Work Order ID 139281

Item Name: Aft Door Assembly

DART SERVICE INSTRUCTION

TO AMEND INSTALLATION INSTRUCTIONS D350-588 REV. D AND
INSTRUCTIONS FOR CONTINUED AIRWORTHINESS ICA-D350-588 REV. 0
REF TCCA STC SH92-41
FAA STC SH1012NE

Figure 1 Striker Plate

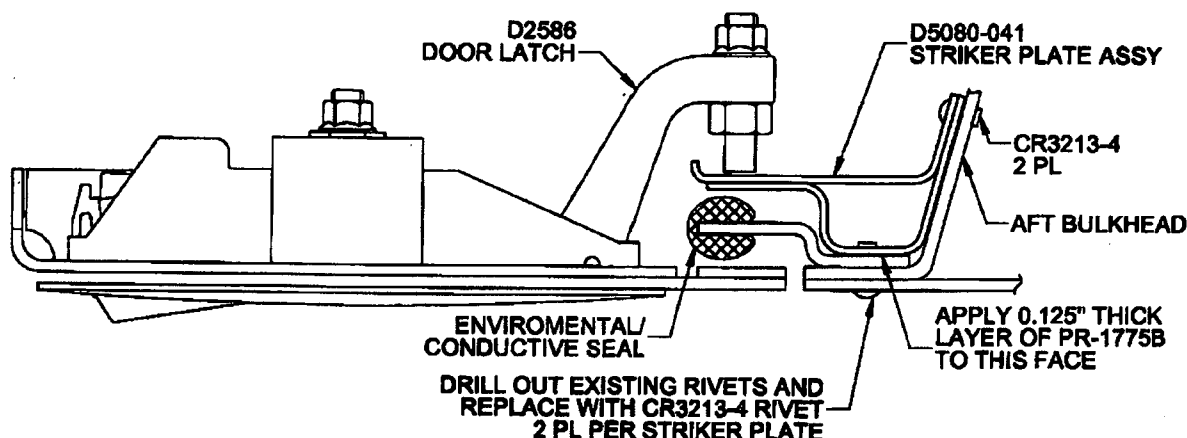
The purpose of this Dart Service Instruction is to provide customers with directions to install a modified striker plate that will provide more clearance around environmental/conductive seals that protrude inboard of the door frame structure on AS355 N/NP models.

- 5) Align D5080-041 striker plate assembly in the previously marked location and transfer drill the $\varnothing 0.1285$ " (#30) holes into the aft bulkhead.

- 8) Deburr holes and remove all sharp edges.
- 9) Touch up all holes in aluminum with chemical conversion coating in accordance with MIL-DTL-5541.
- 10) Apply 0.125" thick layer of PR-1775B ProSeal to the face of D5080-041 per Figure 1.

- 11) Install D5080-041 striker plate assemblies to the aft bulkhead using CR3213-4 rivets of a suitable length, and to the skin of the aircraft using PR-1775B coated CR3213-4 rivets of a suitable length.

588 -041	588 -011	PART NUMBER	DESCRIPTION
X		D350-588-041	AFT DOOR ASSEMBLY
	X	D350-588-011	AFT DOOR FWD HINGE MOD
2	2	D5080-041	STRIKER PLATE ASSY (AS355 N/NP MODELS ONLY)
2	2	D2237	STRIKER PLATE
